## ***Interactive comment on “Reliability of water distribution networks due to pumps failure: comparison of VSP and SSP application” by N. Mehzad et al.***

Responses of the authors to the reviewers’ comments on the paper entitled “Reliability of water distribution networks due to pumps failure: comparison of VSP and SSP application” By N. Mehzad, M. Tabesh, S. S. Hashemi, and B. Atae Kia

**Fig. 1.** The comparison of reliability of two type of pumps (VSP, SSP), with weighted average of four scenarios using three nodal pressure equations.

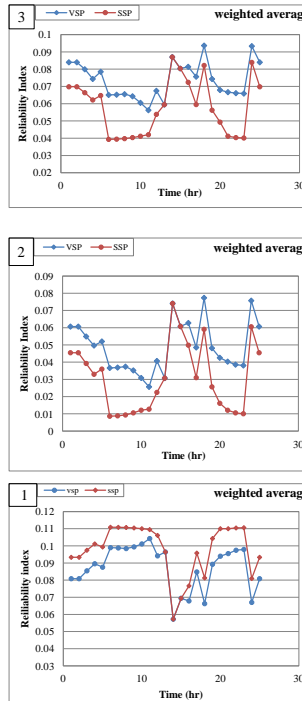
Appendix: figures in page 372 should be replaced by these figures.
